## 概要

この通知は、SBGA パッケージの製品マーキングが変更されることをお知らせするものです。この変更による、フォーム、形状、機能への影響はありません。

この通知は参照用として、英語版 (XCN14025、バージョン 1.0、2014 年 9 月 8 日リリース) を翻訳したものです。

図 1

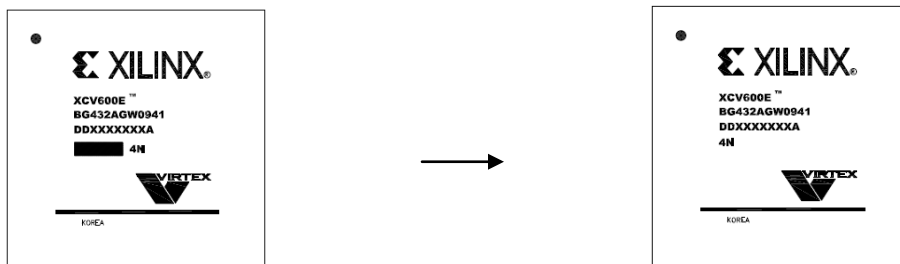
ザイリックスは、すべての SBGA パッケージのトップ マークをインクによる印字からレーザーに変更します。

[図 1](#) に示すように、該当デバイスは次のパッケージ トップマークから特定できます。

現在のマーキング (黒インク)

新しいマーキング (レーザー)
